11 December 2012

Re: Application to modify Development Consent (14/96) St Peters Terminal

In accordance with the provisions of Section 75W of the *Environmental Planning and Assessment Act 1979* and on behalf of our client Boral Resources (NSW) Pty Ltd, we hereby submit this application to alter the layout of the rail siding (Condition 2) which forms part of the approved development of Boral's site at Burrows Road South, St Peters.

Proposed site layout

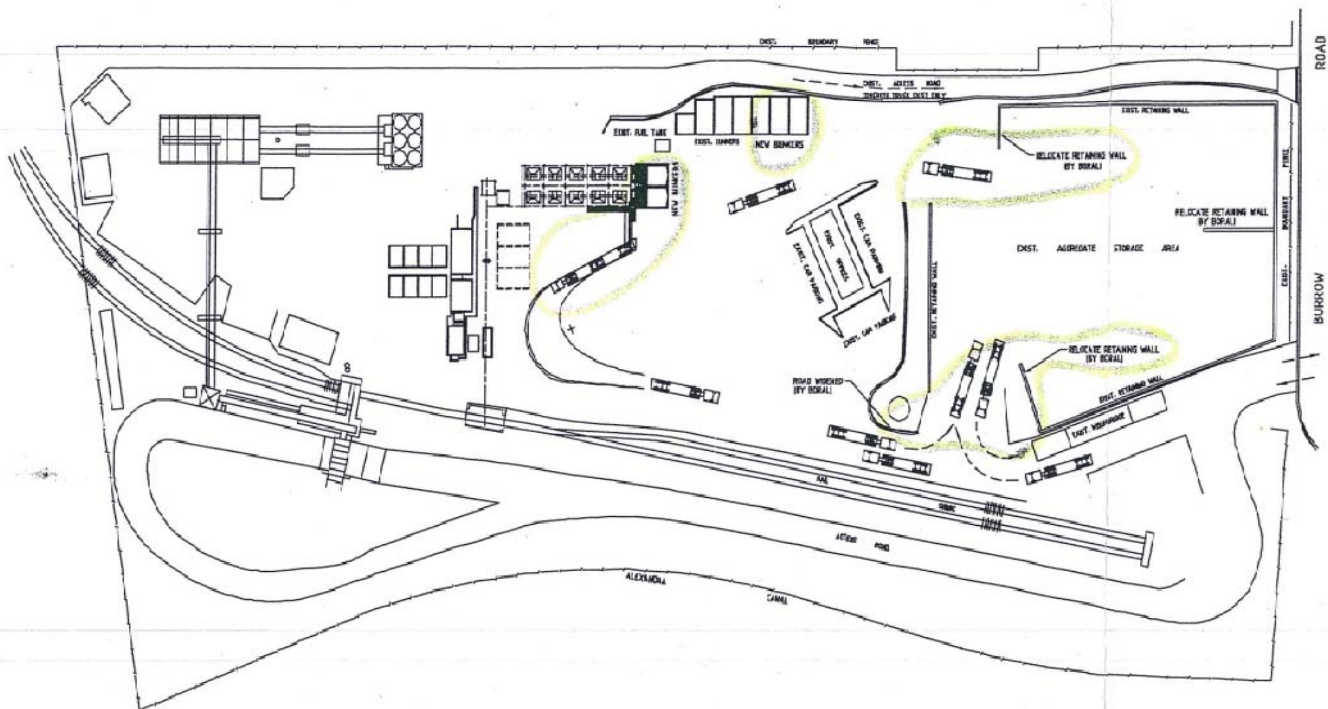
- a 200 m long rail siding which will be constructed parallel to the southern side of the existing rail siding; and
- a cross-over which will be constructed to connect the new rail siding with the existing rail siding.

An additional rail siding is proposed to be built parallel to the southern side of the existing rail siding with a single cross-over connecting the two as indicated in red on the plan 2569-01 (refer to Attachment A). Plan 2569-01 will replace the plan SEK287-C-009 revision D as the approved plan for the site.
